# Historic Preservation Board

**May 11, 2016 at 9:00 a.m.**

Staff Report  
May 11, 2016

COR 16-005 Request by Lien Pham on behalf of Pensco Trust Co. for a Certificate of Review for a two story addition at the residence at 407 Melrose Avenue. A variance is requested to allow a side setback of 7 feet in lieu of the required 20 feet to the lot line; with 25 feet to the street edge. A variance is requested to allow a floor area ratio of 39% in lieu of the allowed 38% Zoned R-1AA.

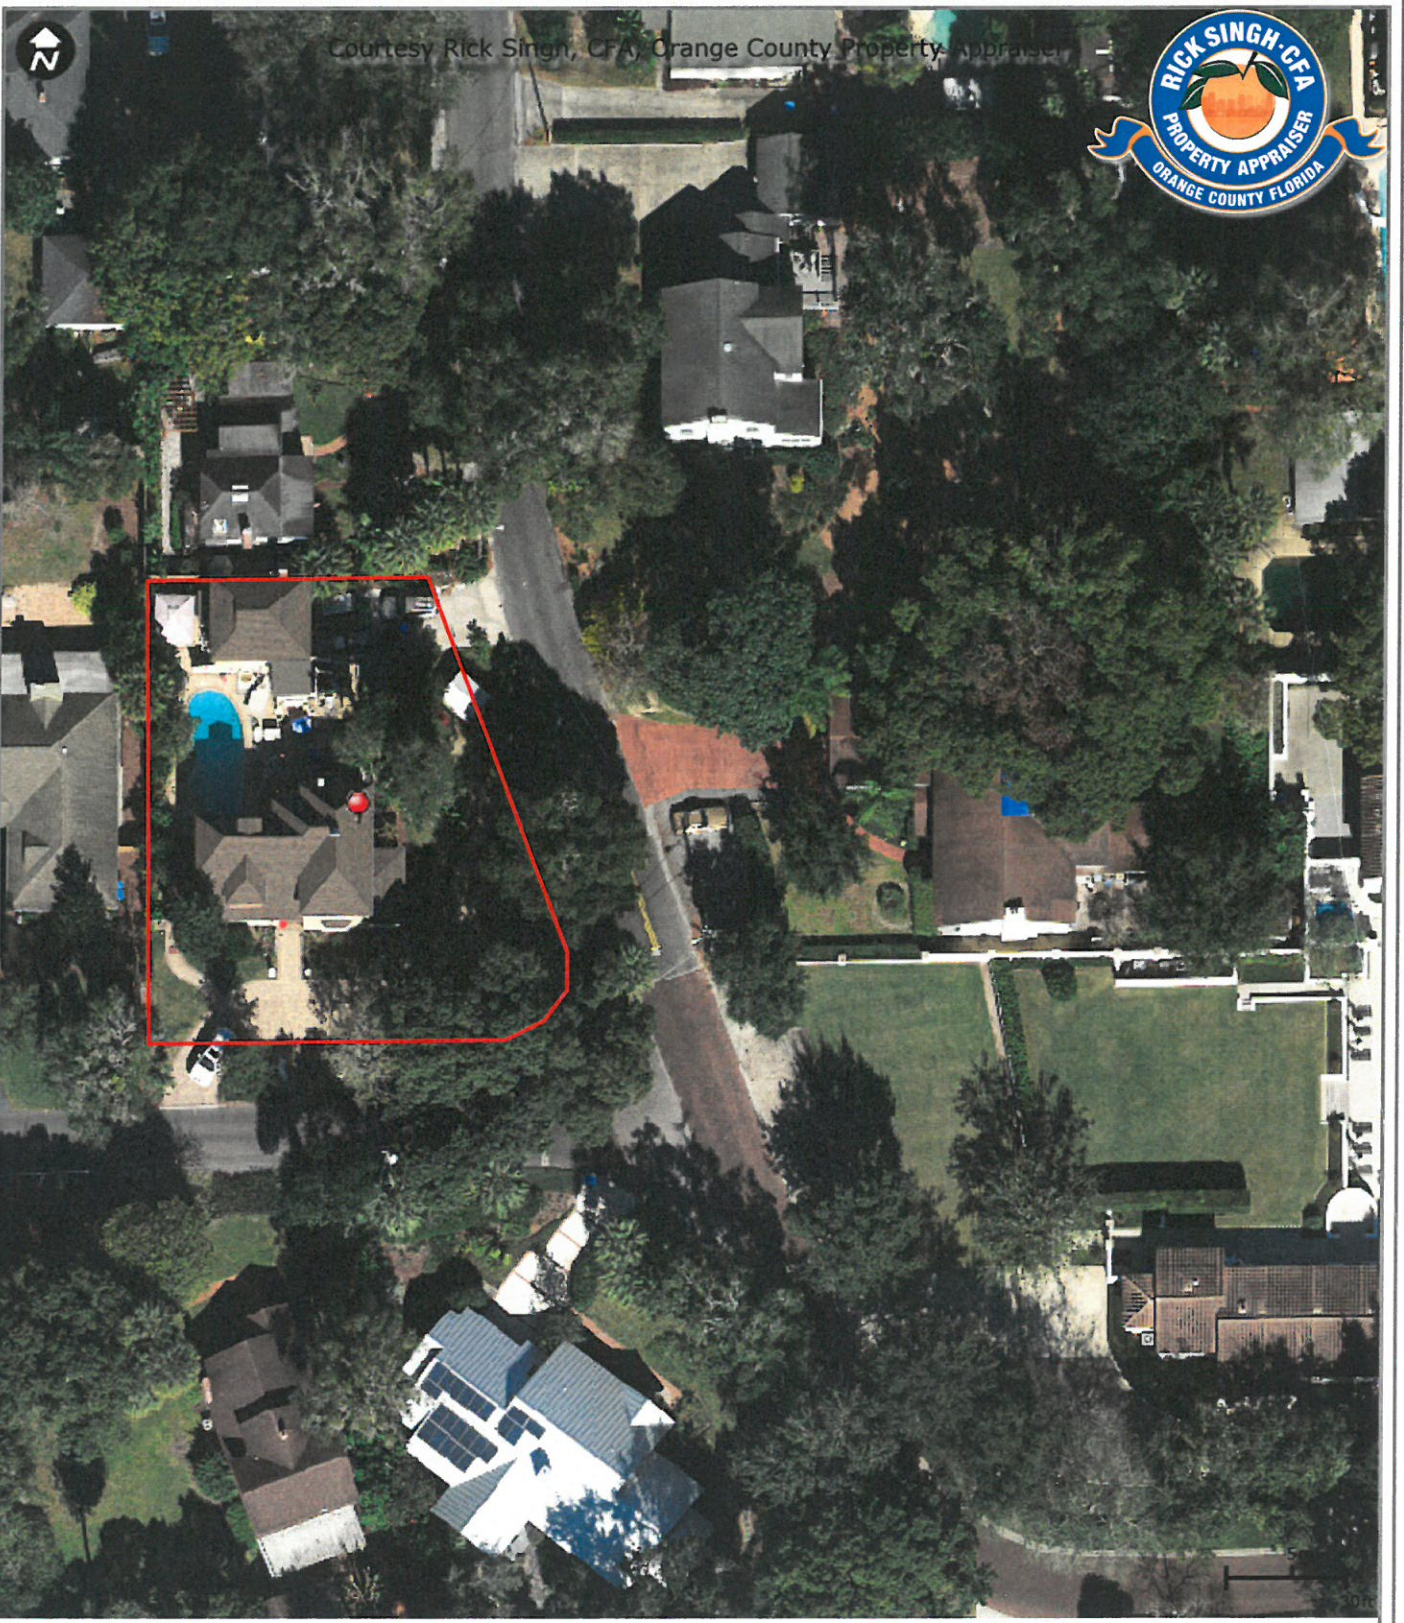
**Certificate of Review Request.** The applicant is proposing to add a two story addition at the northeast rear area of the house behind the sunroom. The rectangular addition would have a hipped roof to be compatible with the original body of the house, and minimize the visual volume from the street. The exterior walls would be clad in stucco to blend with original. Eight and six light casement windows with exterior mullions also coordinate with the original house. On the south facing primary façade, an open porch with a shed roof is proposed across the front of the sunroom. The new rear north facing elevation includes access to a new open deck/balcony off the second floor.

A new balcony is also proposed for the rear elevation of the existing house with the addition of a French door. Both new balconies would have ground floor access from circular stairs and would have aluminum railings. The location of the swimming pool may, in staff's observation, preclude stairs to the separate balcony and will affect the ground support locations.

This corner lot has an irregular shape; tapering toward the shorter rear (north) lot line. The proposed addition is in line with the main body of the house so that the northeast rear corner would require a variance to allow a seven (7) foot side setback from the lot line which is along the Oxford Road side of the property. The bulk of the addition is placed on the wider portion of the side and is further from the lot line and street. There is an eighteen foot right of way along Oxford Road between the subject property and the paved road.

While a portion of open rear porches can be excluded from the allowed floor are ratio (FAR), the application with the addition and rear balconies appears to go over the allowed 38% FAR for the property and a variance is requested for a 39% FAR.

**RECOMMENDATION: Staff Recommendation is for Approval.**

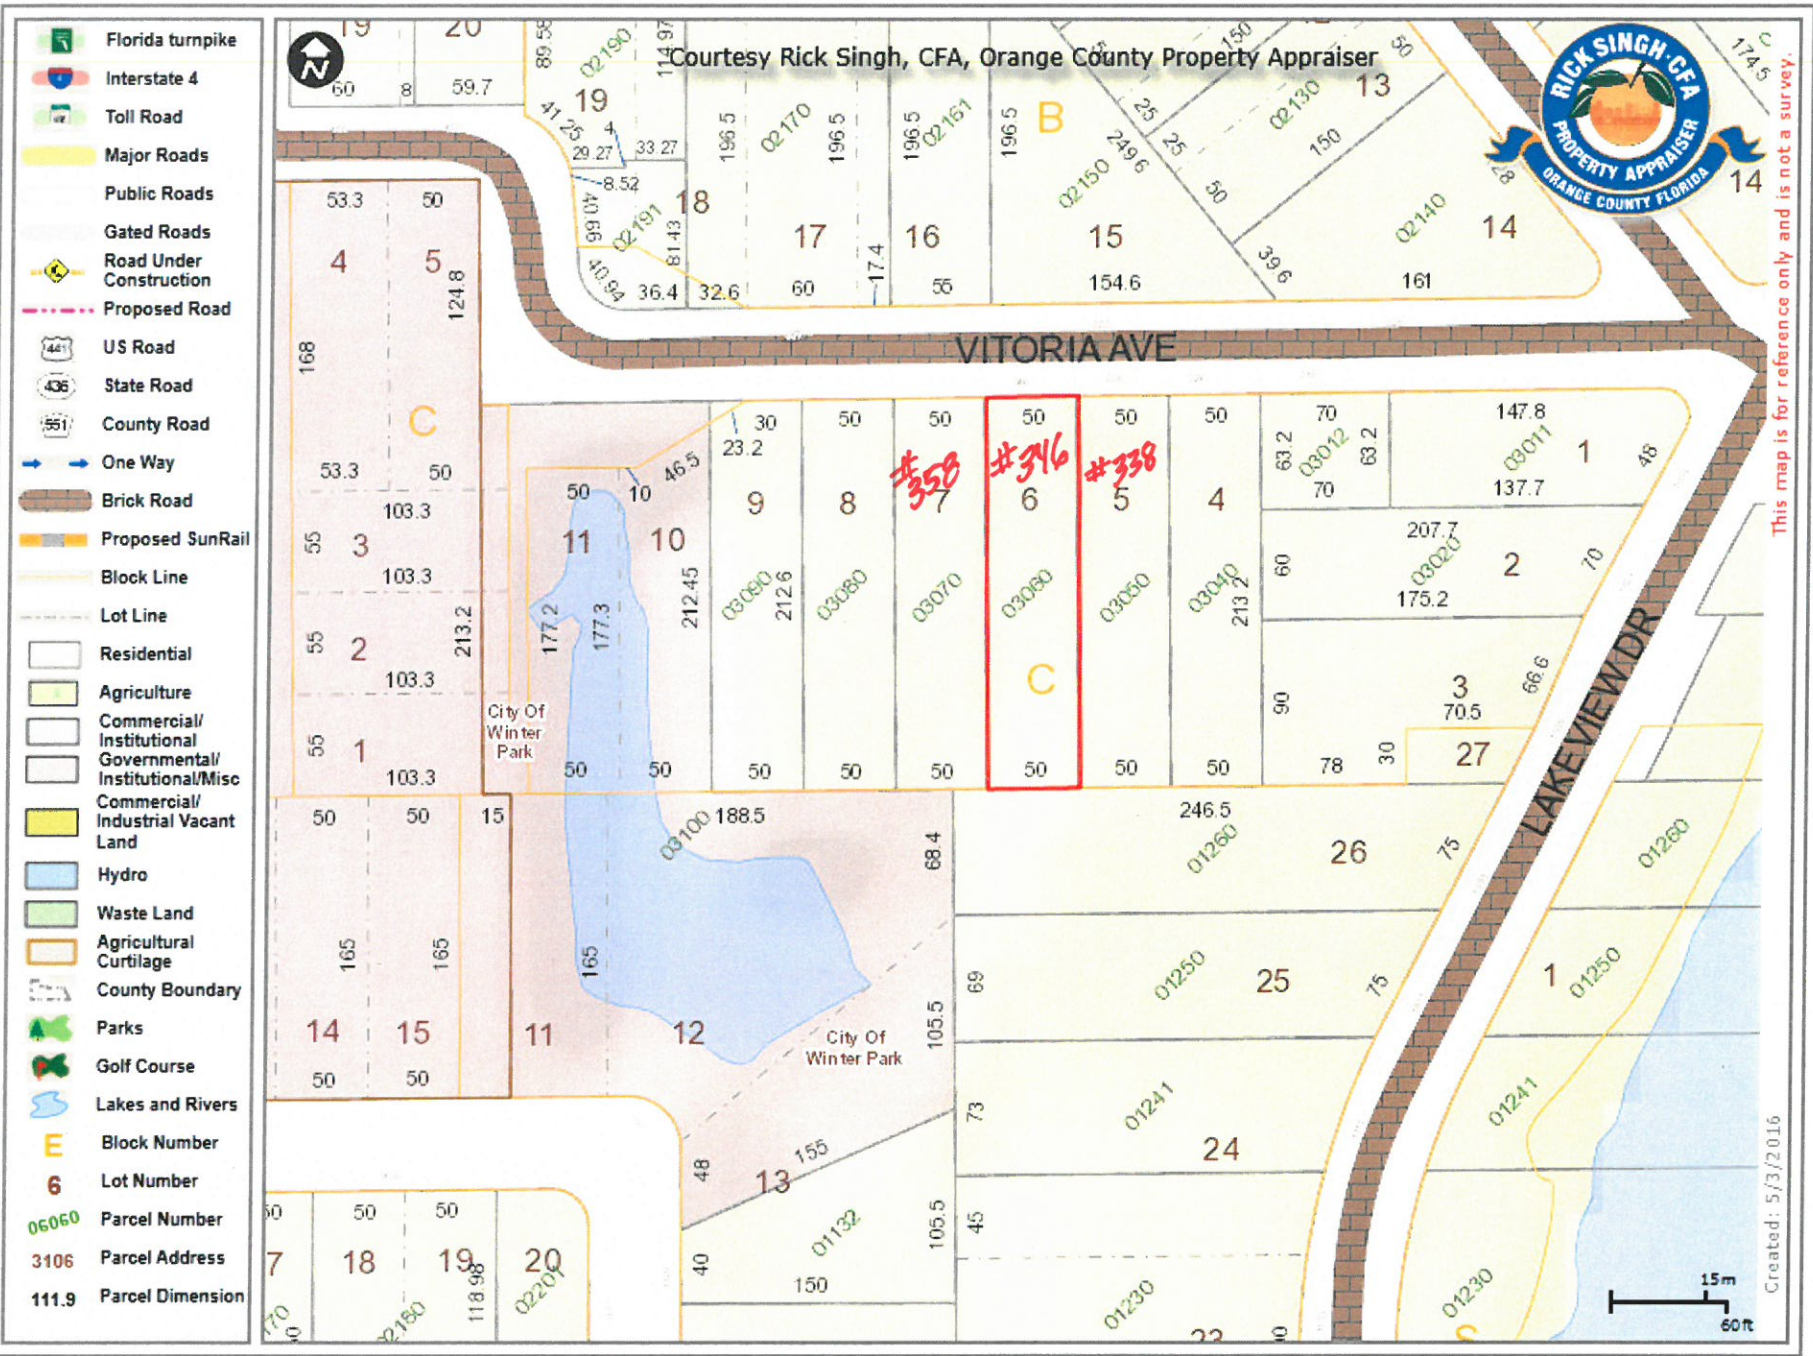
The enclosure of the rear porch and balcony is not visible from the street and has no impact on the historic character. A variance is requested for a continuous wall plane of 45.3 feet on the southeast side elevation in lieu of the required side articulation at 36 feet. The view shed along this side is very limited. The side wall is broken by a recessed arched topped entry. Maintaining the width of the driveway all the way to the rear yard and garage is necessary.

While the new second floor addition is forward of the existing second floor, it is still well recessed from the front of the house and differentiated from the historic façade. A significant visible change occurs at the northwest side elevation where the proposed addition goes up extends to the side elevation; adding a second story up from the existing one story area for a distance of 12.5 feet before ending and moving back to the existing side wall. A variance is requested for a second floor setback of 4.4 feet (the existing one story side setback) in lieu of the required ten foot side setback. This creates a second story "block" along this otherwise one story elevation that is visible from the street.

The abutting neighbor has raised an objection to this portion of the proposal and the variance request due to the proximity to the lot line and the visual impact (statement attached). A compromise was presented that staff recognizes as a solution to the 12.5 foot second story

“block” of the addition on the northwest side. The recommendation is to recess the northwest side portion of the second floor addition back from the side wall plane by 3 feet with a tiled shed roof to make the transition from the second floor to the first. A variance to allow a 7.4 foot side setback to the second floor in lieu of the required ten feet would still be needed. The addition’s massing would be improved and the neighbor would have less visual imposition from the addition. A tiled shed roof would be compatible with the architecture.

1. **Approve the enclosure of the first floor rear porch and second floor balcony; granting a variance to allow a continuous sidewall plane of 45.3 feet in lieu of the required 36 foot side wall articulation.**
2. **Approve the second floor addition with the condition that the northwest side wall of the second floor be recessed 3 feet from the first floor side wall plane with a tiled shed roof transition; granting a variance to allow a 7.4 foot side setback to the second floor addition.**

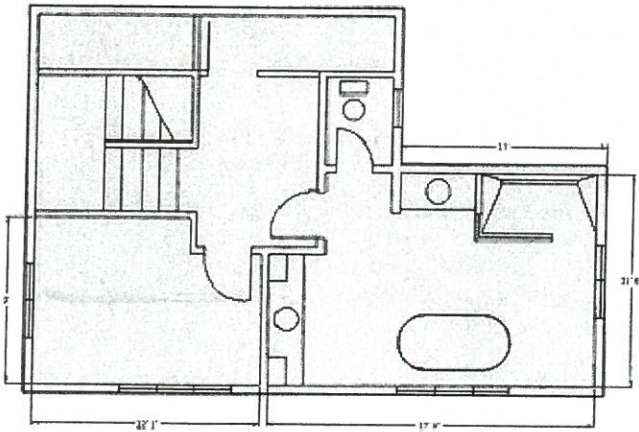
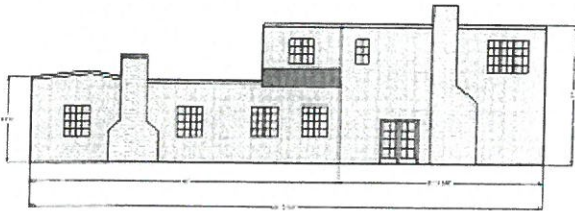
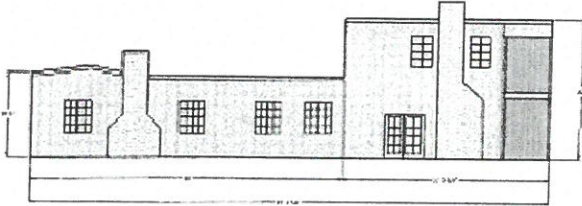
To extend this unfortunate disconnect in architecture by placing a vertical wall a mere 4'5" from our property line in lieu of 10.0' would be imposing, unfortunate, and unfair to me and my family. This wall, as represented on the plans, would extend over 20' straight up, additional square footage for sure but doing nothing to soften the abrupt transition from the charming front facade to the boxy addition.

I think the following represents a reasonable solution. This is so close to the property line that I believe it would require a fire rated wall.

**Symmetry:** I understand the desire for the second floor front elevation to align with the wall on the right, albeit 49' back from the front plane and not so noticeable. It's appropriate to note that symmetry isn't an established characteristic on the home, nor should it be. The first floor architecture is beautiful, and asymmetric.

**Side set back:** In lieu of the 4'5" side setback proposed on the second floor or the required 10'0" setback one could do the following. If the addition were pulled back just three feet then a small tile roof, matching the front of the home, would break up the excessive plane and provide some open space, minimizing the "canyon" effect. This would result in a second floor side setback of 7'5" in lieu of 10'0", still a sizable variance but acceptable for us.

**Windows:** The lack of windows on the walls were perhaps intended to minimize the sense that our privacy is compromised, if so, we appreciate the consideration. The aesthetics are begging for windows. Window treatment would likely stay in place removing the privacy concerns with a benefit of soft bathing afternoon sunlight on the interior space, the "magic hour, so to speak, brought inside. The small window in the toilet room would serve likewise.
